*****RECALL NOTICE*****

NHTSA Recall # 06V-416

FMVS 111 Crossover Mirror Warning Label			RECALL#06V-416
BY: Jose Vasquez	DEPARTMENT: Warranty/ Recalls	DATE: 11/06/2009	REVISION: 2

US Bus Corporation Universe and Sturdibus School Buses manufactured between January 1, 1998 thru October 23, 2006

Figure 1

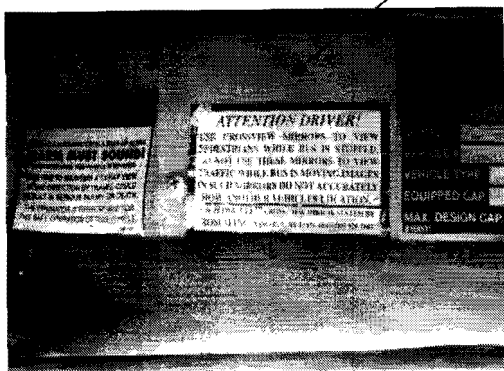
1. Open the Drivers door and inspect the header above the driver seat for the Crossover mirror label as show in **Figure 1**.
2. If the crossover mirror label is obscured by vehicle's rear view mirror as show in **Figure 2**. Then the vehicle requires the remedy.
3. Affix the label supplied as show in **Figure 3** to the left side of the drivers steering wheel on the dash as shown in **Figure 4 and 5**.

Decal installed on front header

Figure 3

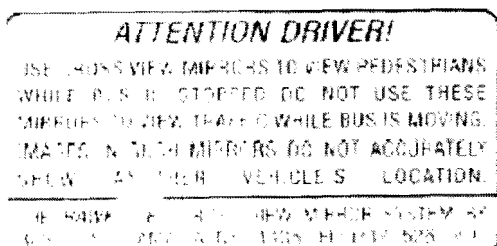
Required label as per FMVS 111
